PCD Project Number: PPR-21-17

WATERMARK AT AKERS
GRADING EROSION CONTROL PLAN

Grading & Erosion Control Plan_V1.pdf Markup Summary

C2.0

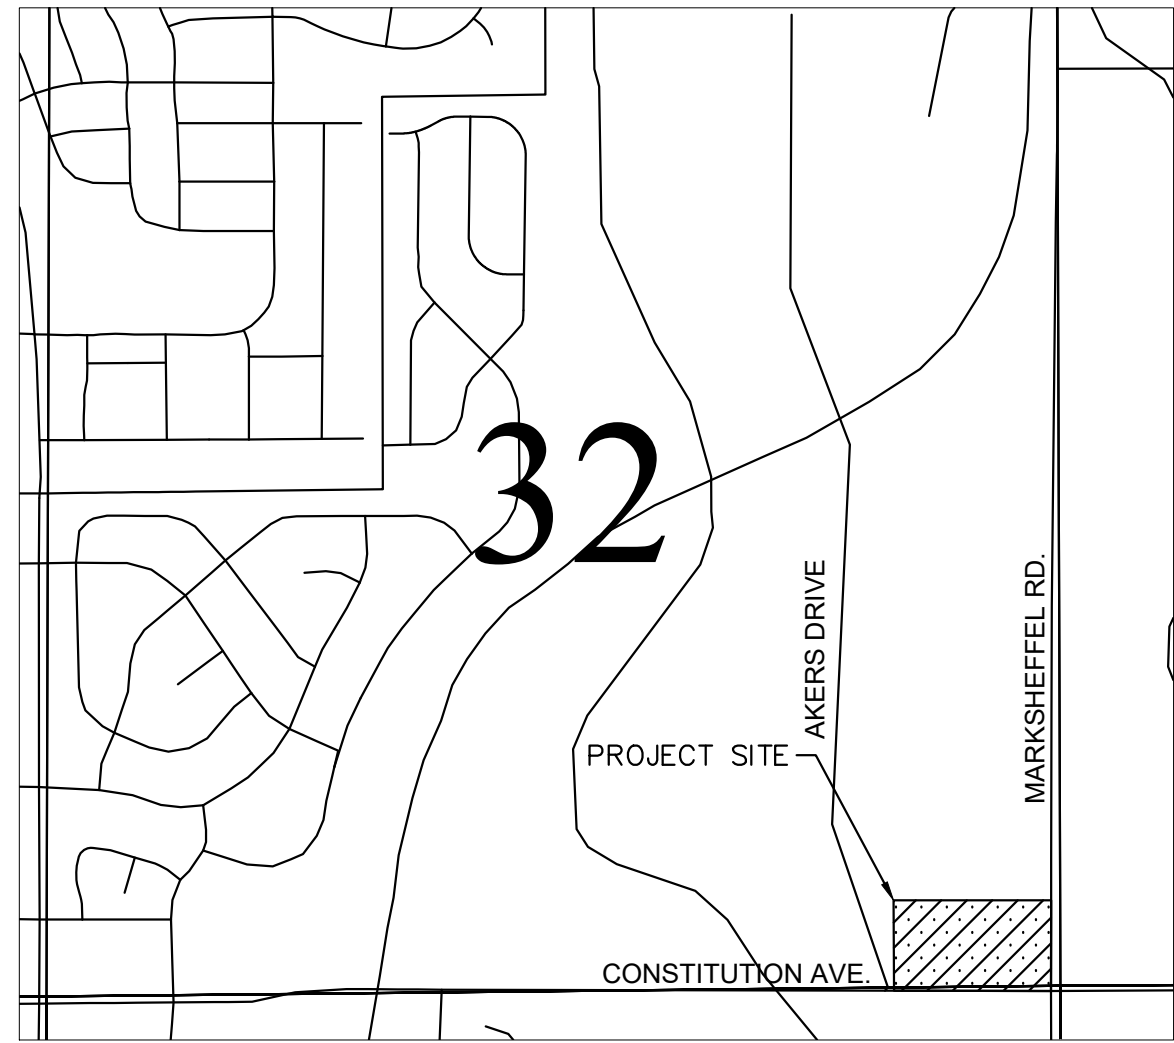
Please use signature blocks for a Standalone GEC Plan (See GEC Checklist items ff and hh)

SWMP states that the soils report was prepared by Kumar and Associates, dated 9/20/2020. Please confirm.

SHEET
C2.1

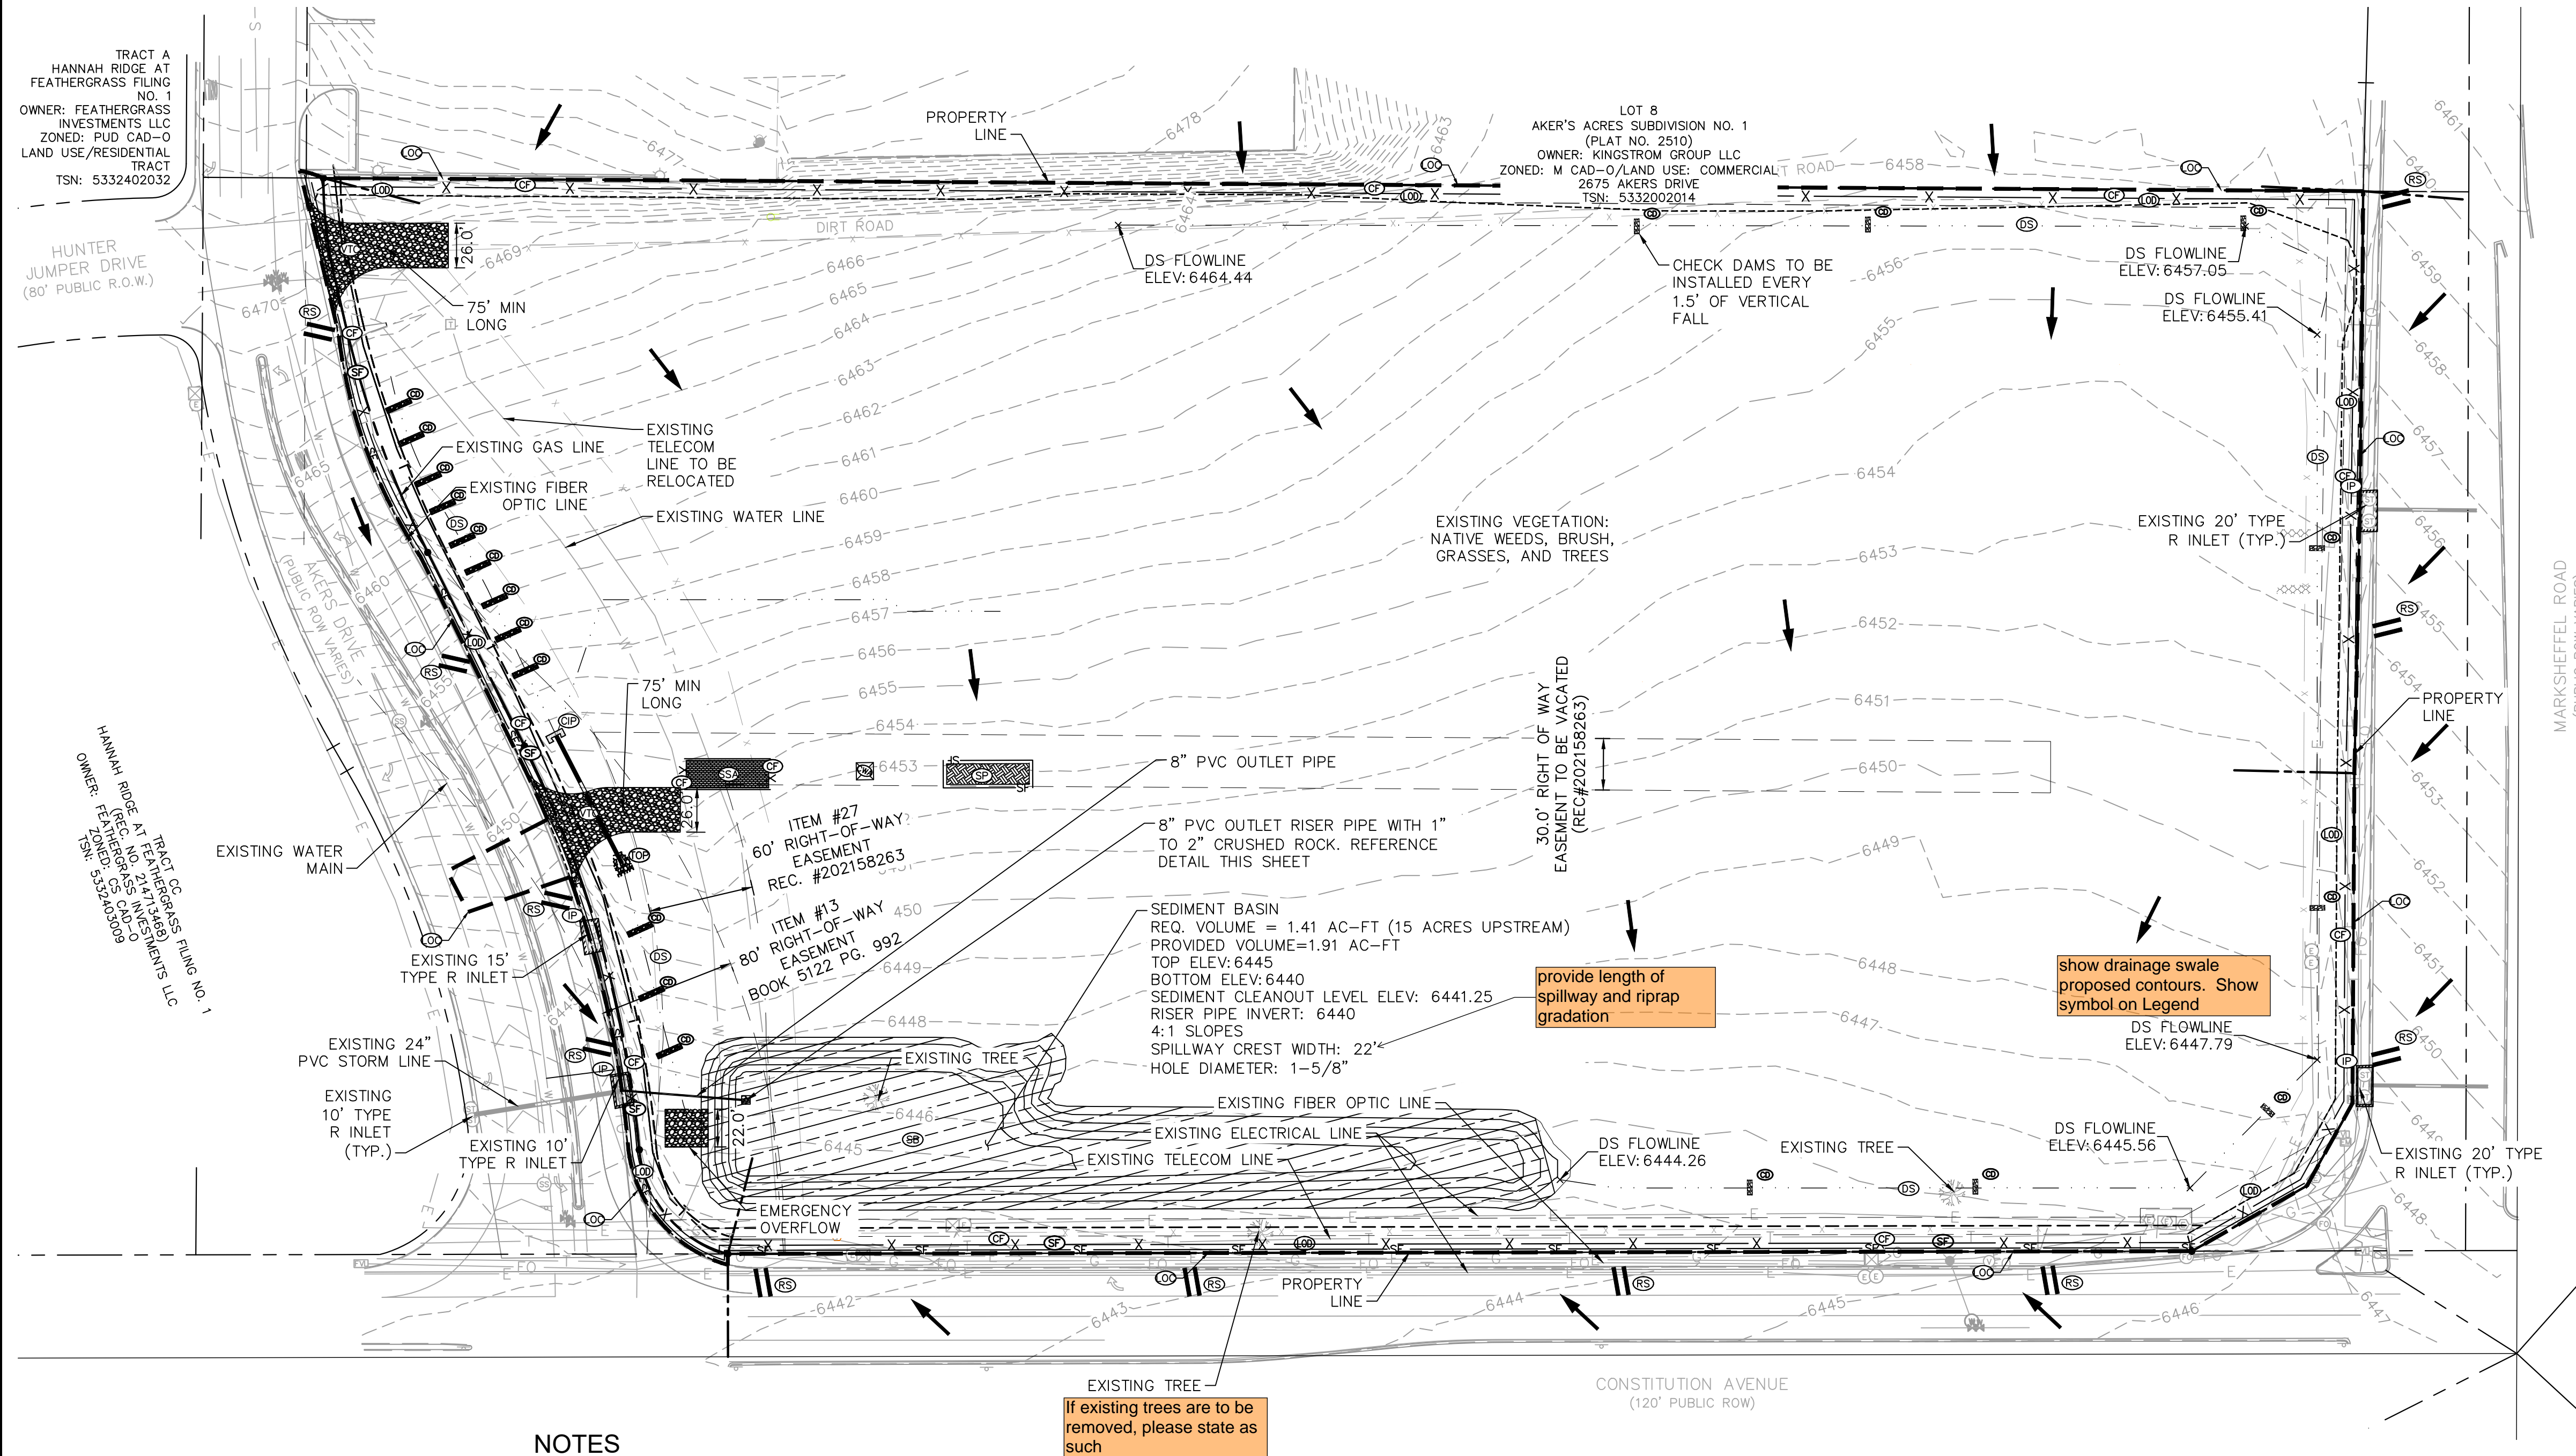
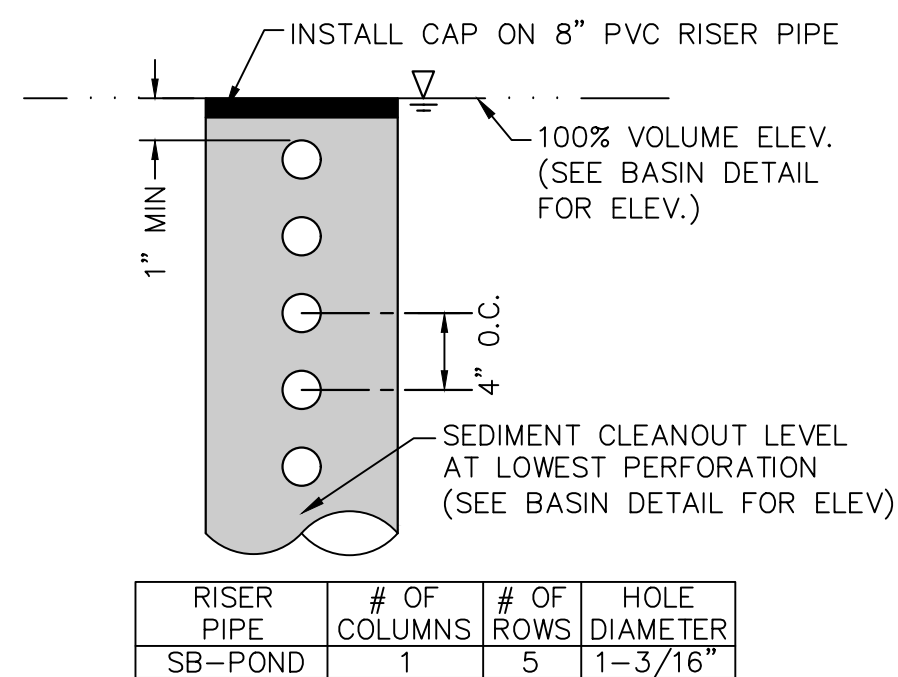
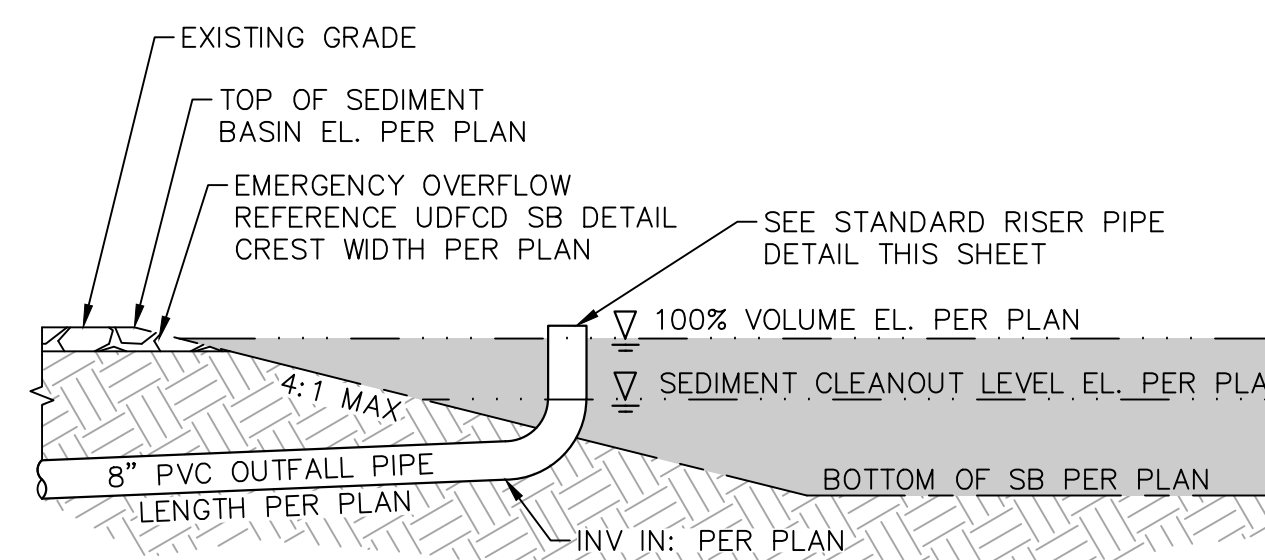
If existing trees are to be removed, please state as such

show drainage swale proposed contours. Show symbol on Legend

provide length of spillway and riprap gradation

C2.2

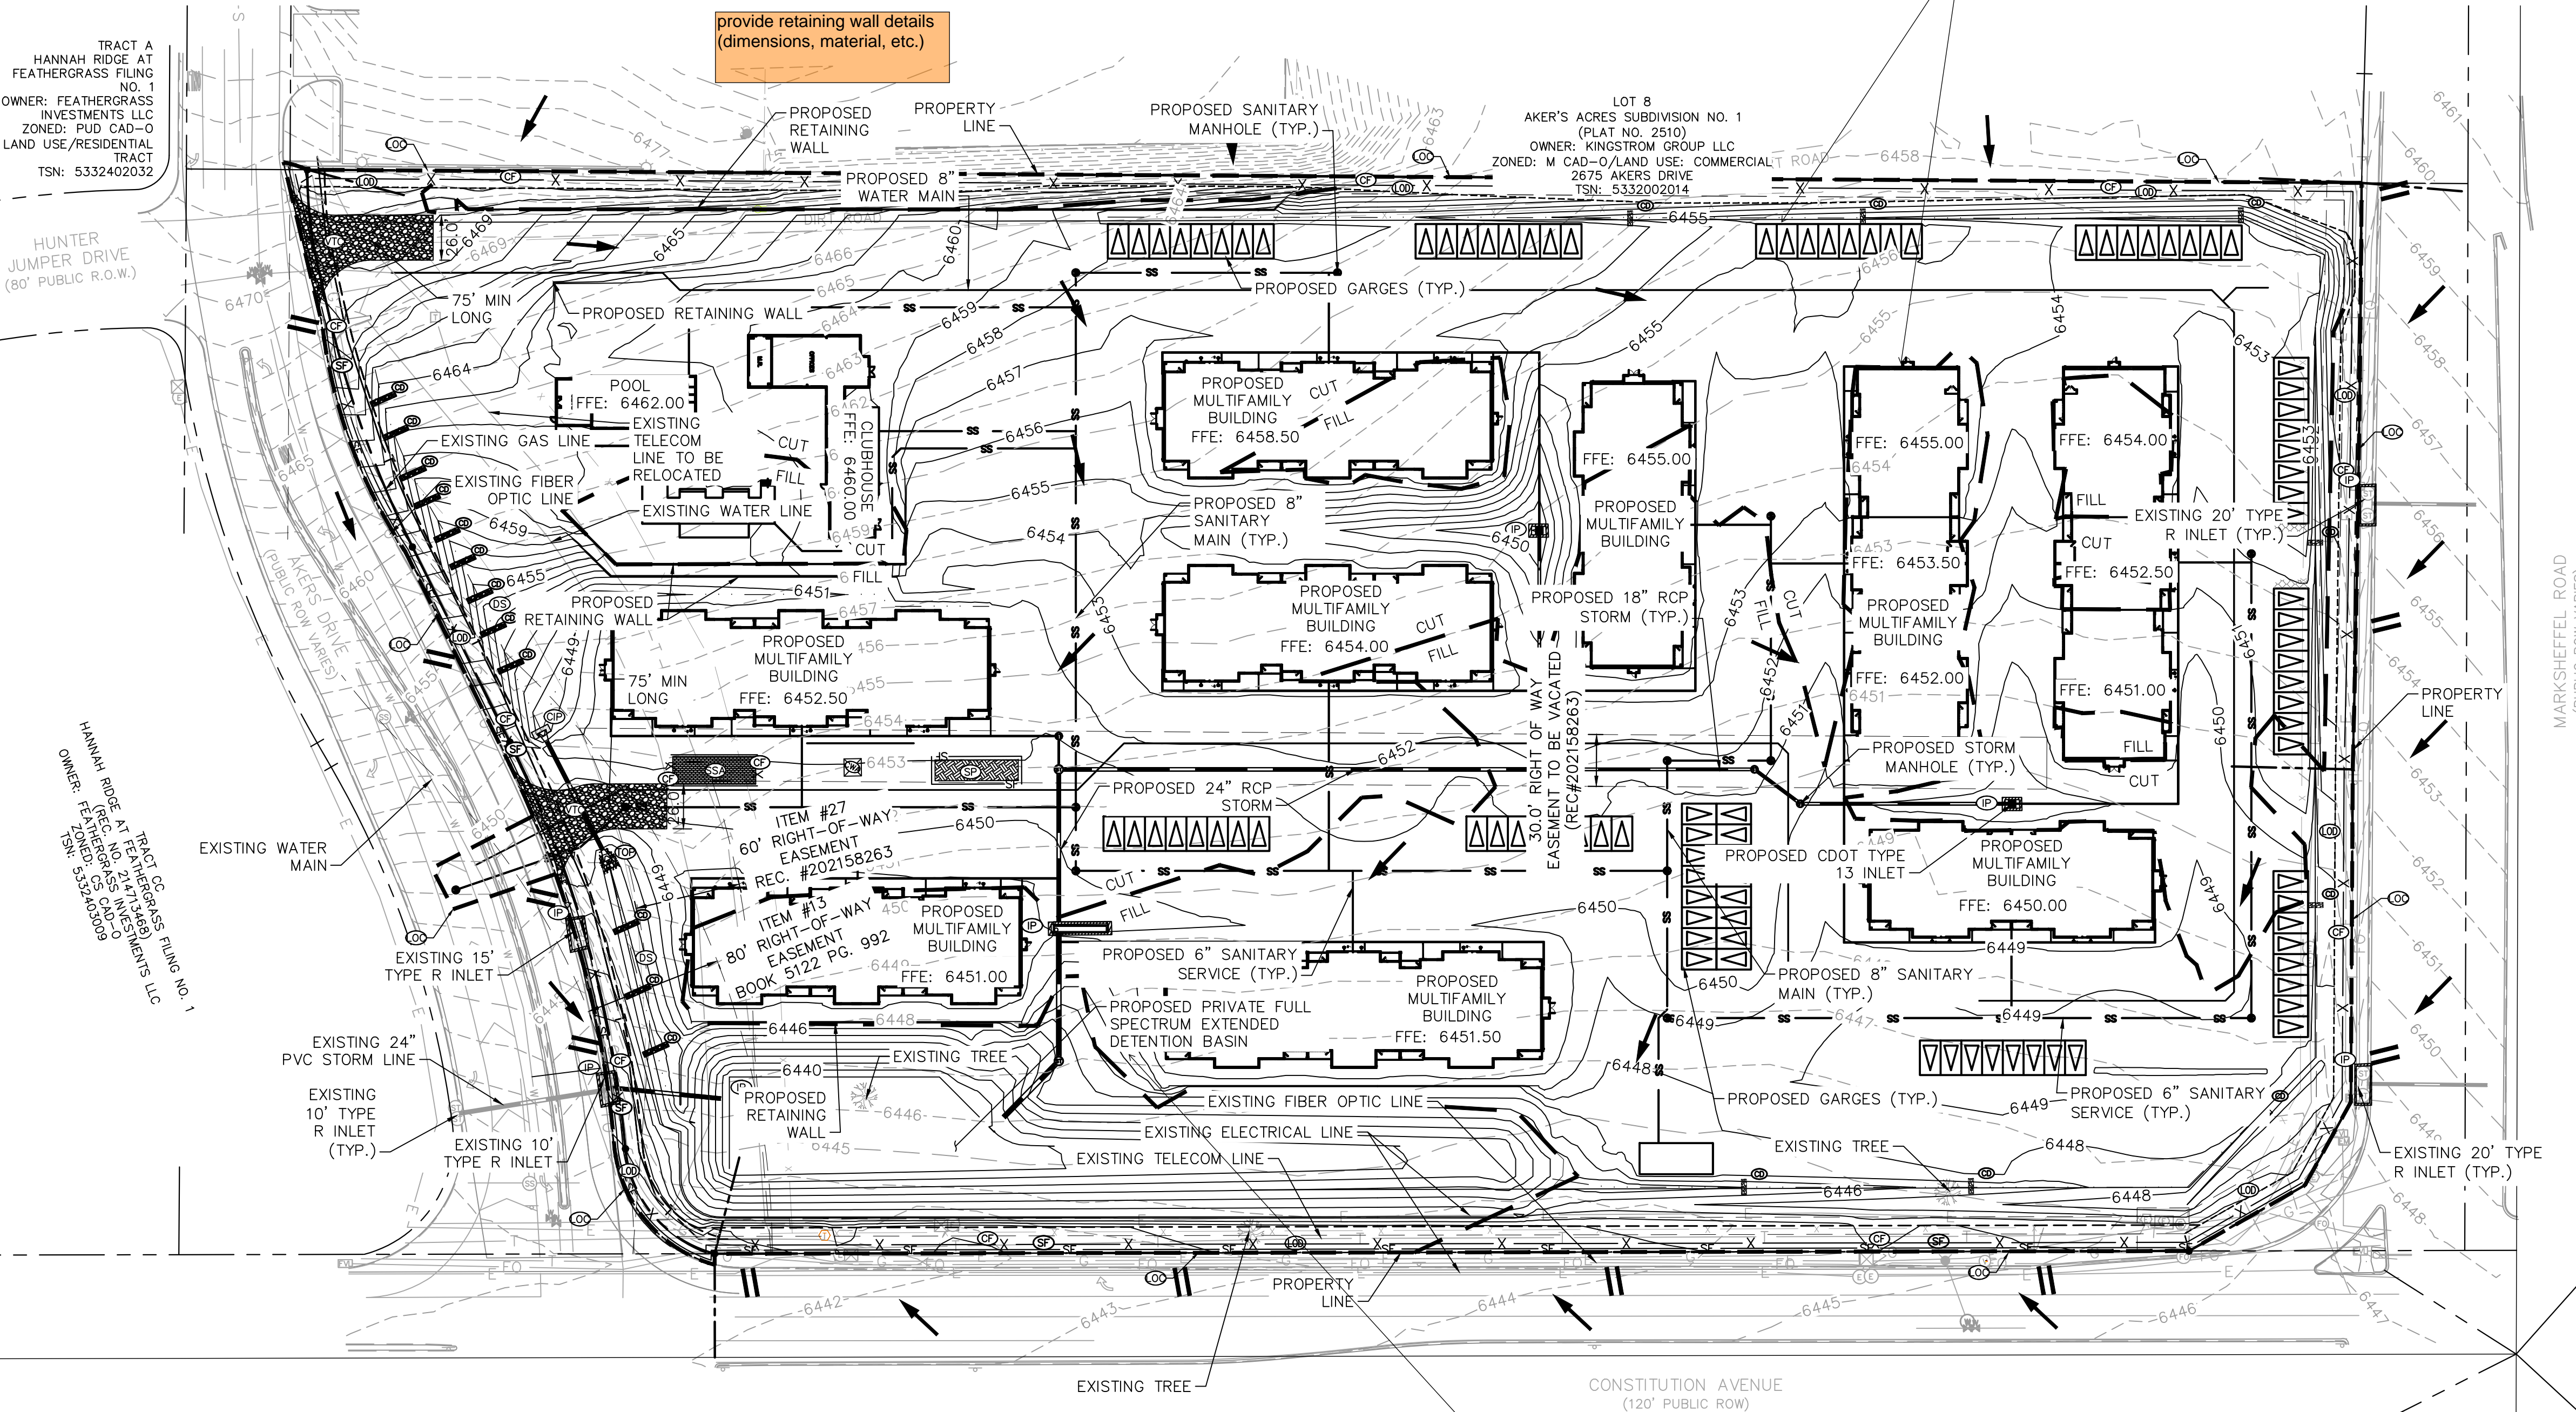
add a note stating that
the pond details are in
the CDs Sheet C3.22

remove all proposed buildings as they are not part of the interim phase

add a note stating that the pond details are in the
CDs Sheet C3.22

provide retaining wall details (dimensions, material,
etc.)
